ATTACHMENTS: REPORT 4.1 CONSIDERATION OF PRECINCT 8 - RANCH ROAD LOCAL STRUCTURE PLAN FOLLOWING ADVERTISING

COUNCIL MEMBERS' BRIEFING SESSION

Consideration Advertising	of Precinct 8 - Ranch Road Local Structure Plan Following
Attachment 1:	Attachment 1 - East Wannerroo District Structure Plan 2
Attachment 2:	Attachment 2 - East Wanneroo Precinct 8 - Ranch Road - Part 1 and LSP Map
Attachment 3:	Attachment 3 - East Wanneroo District Structure Plan - Staging
Attachment 4:	Attachment 4 - Precinct 8 - Schedule of Modifications V418
Attachment 5:	Attachment 5 - Location Plan Precinct 828
Attachment 6:	Attachment 6 - Flow Chart - East Wanneroo Progression29
Attachment 7:	Attachment 7 - MRS Map30
Attachment 8:	Attachment 8 - Submission Schedule for Council -precinct 8 LSP V5
Attachment 9:	Attachment 9 - Lifting of Urban Deferment
Attachment 10	: Attachment 10 - LSP Boundary Variations 177
Attachment 11	: Attachment 11 - Community Facilities Plan 178
Attachment 12	: Attachment 12 - POS Schedule and Plan 179
Attachment 13	: Attachment 13 - East Wanneroo - Precinct 8 - Ranch Road - Landscape Strategy

Figure 1.16: Staging Plan

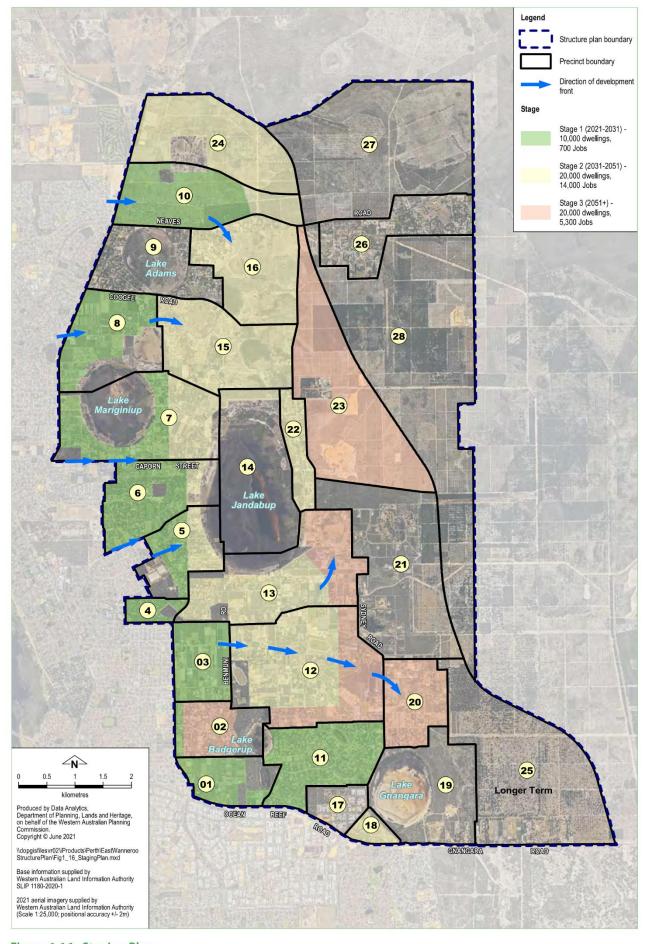
No.	Summary of Submission	Administration Comment	Recommendation
	Department may consider that Stage 1 in Figure 1.16 in the District Structure Plan (October 2020) could progress if OFFICIAL appropriate land is being set aside for flood management and there is provision for future	9.1.1 - The LSP is located on cleared land as much as possible and protects more of the native vegetation that envisaged in the approved EWDSP. All of the vegetation in the highest	
	connection to a district scale groundwater management scheme. Consideration of local water management strategies for Stages 2 and 3 would be made once the district scale solution was resolved.	condition is retained and areas of degraded vegetation in the buffer to the lakes will be revegetated, enhancing the environmental values	
	Planning requirements and technical matters for the area that must be undertaken prior to structure planning were detailed in the following sections of the DWMS: 5.1 Protection of important environmental assets and water resources, 5.2 Management of groundwater at district scale, 5.2.4 Construction & Governance options, and 6.3 Developer contributions plan requirements.	of these areas. 9.1.2 - This comment is not relevant to the Precinct 8 Structure Plan. The Structure Plan shows a road along the boundary of the lakes (except in areas that have adjoining POS to
